Contract #: 04-0120F4Cty: SF/ALA Rte: 80 PM: 13.2/13.9File #: 69.25B**QUALITY ASSURANCE -- NON-CONFORMANCE REPORT****Location:** Changxing Island, Shanghai, PRC**Report No:** NCR-000446**Prime Contractor:** American Bridge/Fluor Enterprises, a JV**Date:** 14-Oct-2009**Submitting Contractor:** Zhenhua Port Machinery Company, Ltd (ZPMC), Changxing Island**NCR #:** ZPMC-0419**Type of problem:**

Reference Description: Missed MT indication on West Tower, Lift 3, DE Corner Seam weld**Description of Non-Conformance:**

To: AMERICAN BRIDGE/FLUOR, A JV **Date:** 17-Oct-2009
 375 BURMA ROAD
 OAKLAND CA 95607 **Contract No:** 04-0120F4
 04-SF-80-13.2 / 13.9
Dear: Mr. Charles Kanapicki **Job Name:** SAS Superstructure
Attention: Mr. Thomas Nilsson Project/Fabrication Manager **Document No:** 05.03.06-000409
Subject: NCR No. ZPMC-0419
Reference Description: Missed Indication (MT) / West Shaft Lift 3 / DE Corner Seam Weld

NCR PROPOSED RESOLUTION

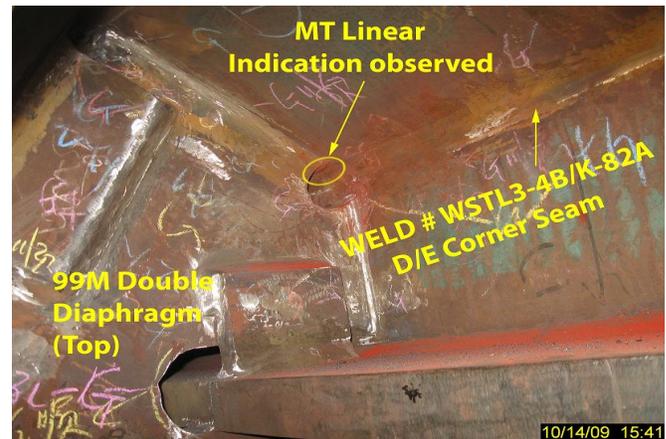
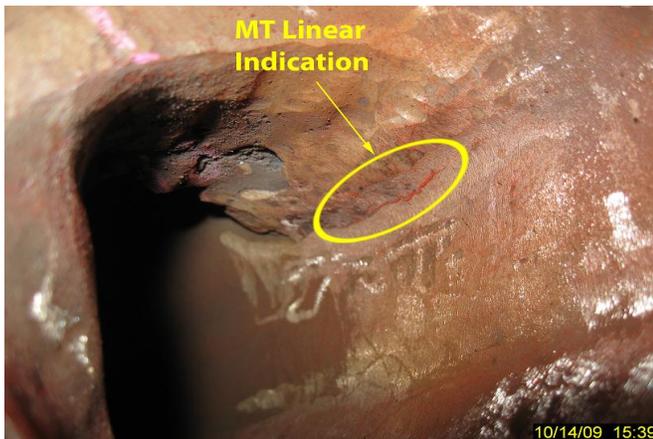
During Magnetic Particle Testing (MT) of West Tower, Lift 3, DE corner seam weld WSTL3-4B/K-82A, QA discovered a linear indication of approximately 30mm in length near the 99 m Double Diaphragm (top plate). This weld had been previously tested and accepted by ZPMC NDT personnel (NDT Inspection Notification sheet # 004401).

Reference Description: Missed MT indication on West Tower, Lift 3, DE Corner Seam weld

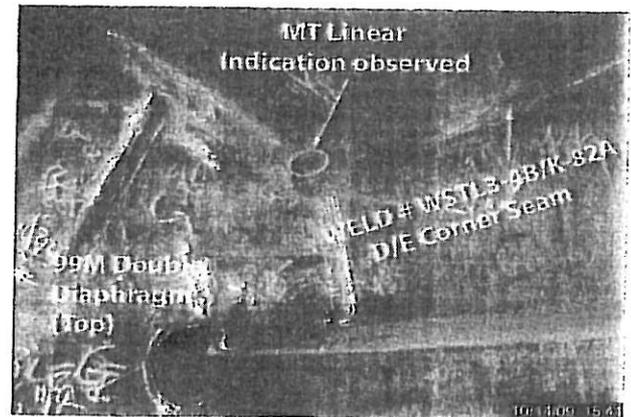
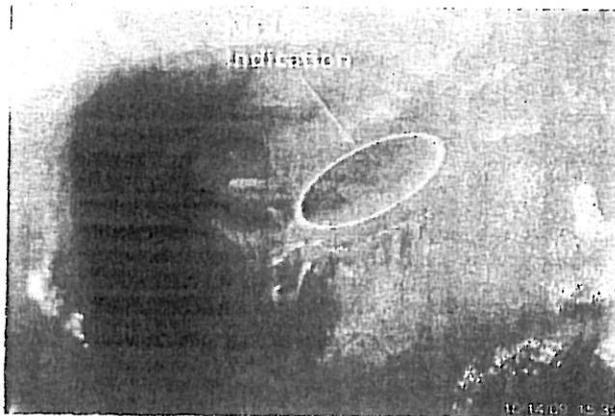
During Magnetic Particle Testing (MT) of West Tower, Lift 3, DE corner seam weld WSTL3-4B/K-82A, QA discovered a linear indication of approximately 30mm in length near the 99 m Double Diaphragm (top plate). This weld had been previously tested and accepted by ZPMC NDT personnel (NDT Inspection Notification sheet # 004401).
